NL-04-0318

Joseph M. Farley Nuclear Plant Units 1 and 2
Application for License Renewal –
January 22, 2004 and February 3, 2004 Requests for Additional Information

Joseph M. Farley Nuclear Plant Units 1 and 2
Application for License Renewal-
Responses to January 22, 2004 and February 3, 2004
Requests for Additional Information

RAI 4.3.4-1c

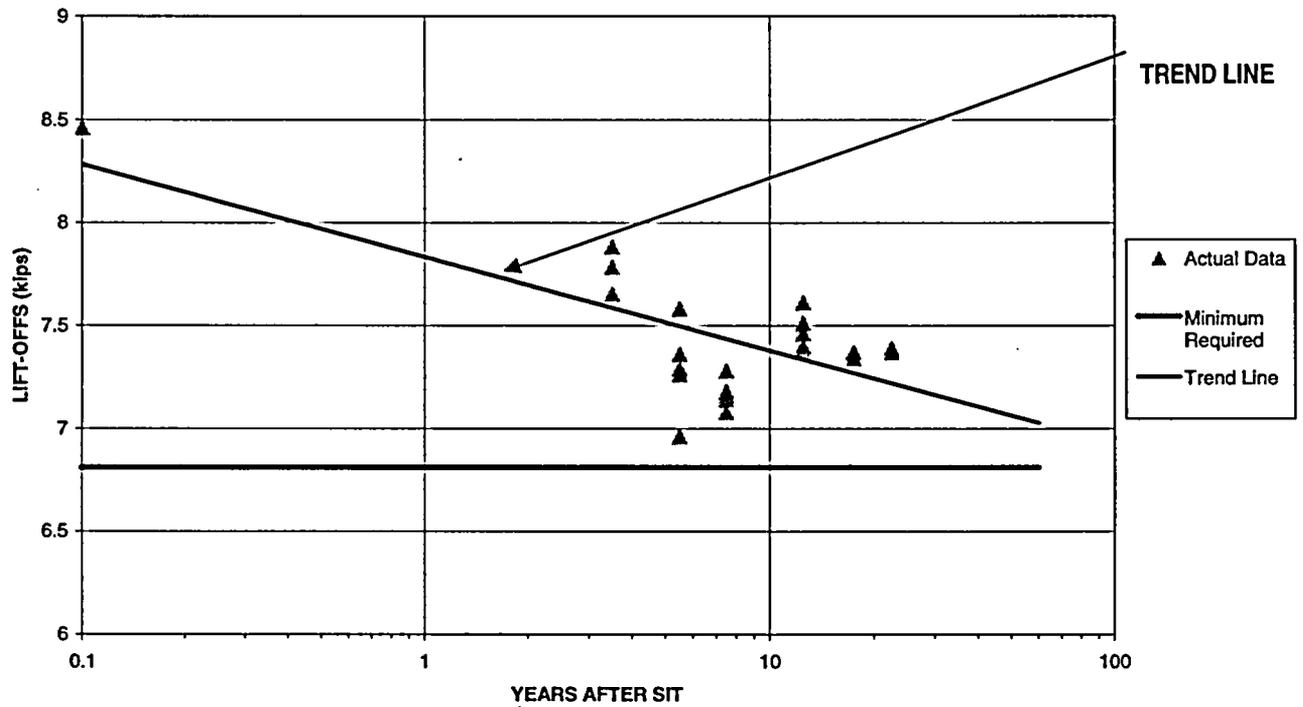
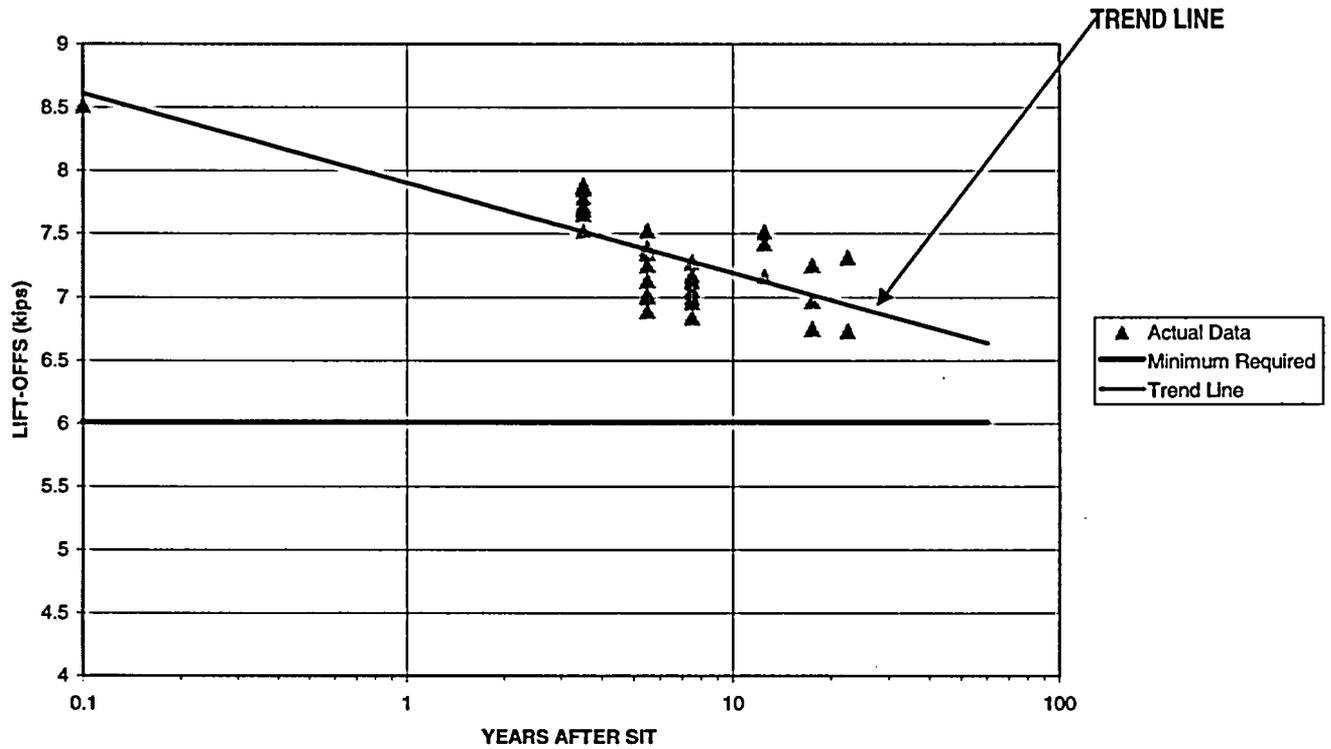
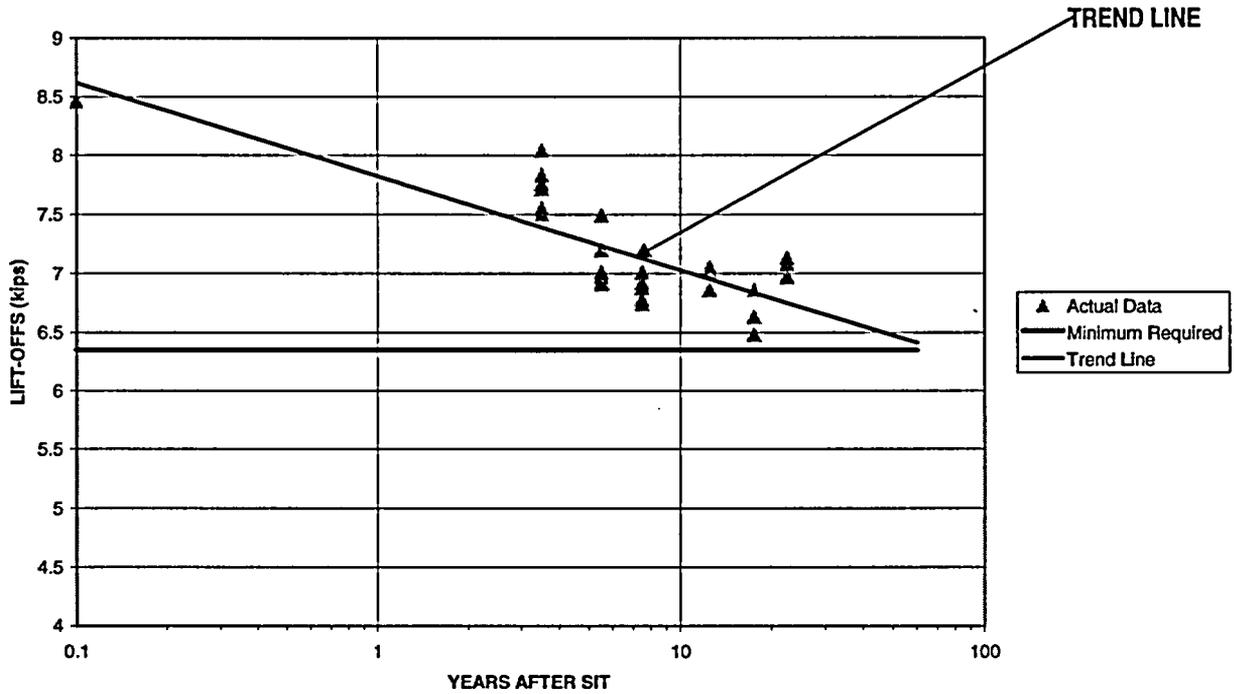
10CFR54.21(c)(1)(ii) requires that the applicant demonstrate the adequacy of the analysis projected for the extended period of operation. In order for the staff to make a reasonable assurance conclusion, the applicant is requested to provide the following information:

- (c) Plots showing comparisons of prestressing forces projected to the end of the extended period of operation with the minimum required prestress for each group of tendons.

Response

UNIT 1 VERTICAL TENDONS
ACTUAL FORCE TREND
(from past 6 surveillances)

UNIT 1 HOOP TENDONS
ACTUAL FORCE TREND
(from past 6 surveillances)

UNIT 1 DOME TENDONS
ACTUAL FORCE TREND
(from past 6 surveillances)
